NUREG-0040
Vol. 17, No. 4

Licensee Contractor and Vendor Inspection Status Report

Quarterly Report
October-December 1993

SUBJECT: NRC INSPECTION REPORT 99900404/93-01

Figure 1. X-relay Magnetic Core

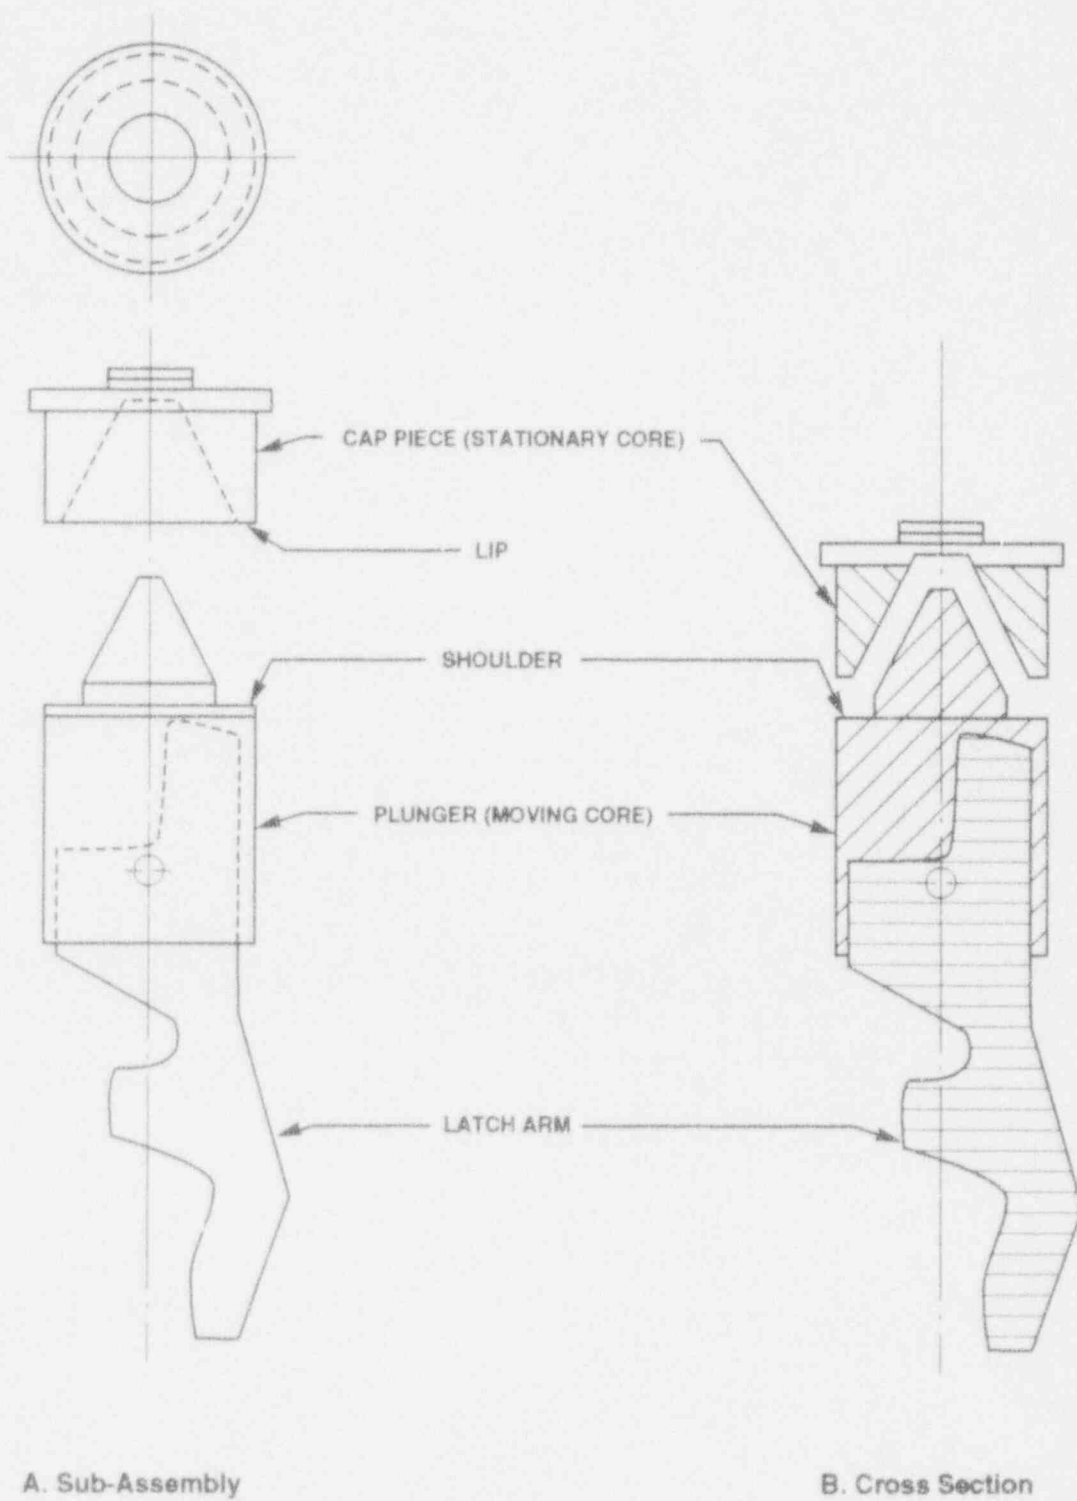
The armature assembly (see Figure 1) of an X-relay which fits inside a brass sleeve is surrounded by the relay's electromagnetic coil. When the coil is energized, the plunger (moving core) is drawn up towards the top cap piece (stationary core) of the assembly and the latch arm operates the relay's contacts. In its uppermost position an air gap is maintained between the bullet-shaped top of the plunger and the cavity in the cap piece with the shoulder of the plunger mating with the lip on the cap. When the coil is de-energized, the moving core is designed to fall, by gravity, into its lowermost position. The failure of the moving core to fall to its lowermost position is the possible failure mode of interest at Haddam Neck.

Possible causes of the failure mode of the X-relays discussed during the AIT are:

- Residual magnetism which can prevent the moving core from falling to its lower-most position.

- Mechanical binding due to dirt accumulation between the moving core and the brass sleeve.
- Mechanical binding due to different coefficients of thermal expansion caused by heat dissipated by the energized coil.
- Dimensional variations of the X-relay frame.

On September 9, 1993, at W, in the presence of the NRC, a Haddam Neck engineer was able to cause the two parts to adhere to each other and prevent the moving core to fall freely by gravity by applying pressure to the plunger and the top cap piece of the armature while twisting them together. W and the licensee believe that residual magnetism or mechanical adherence are two of the probable causes for the parts sticking together.
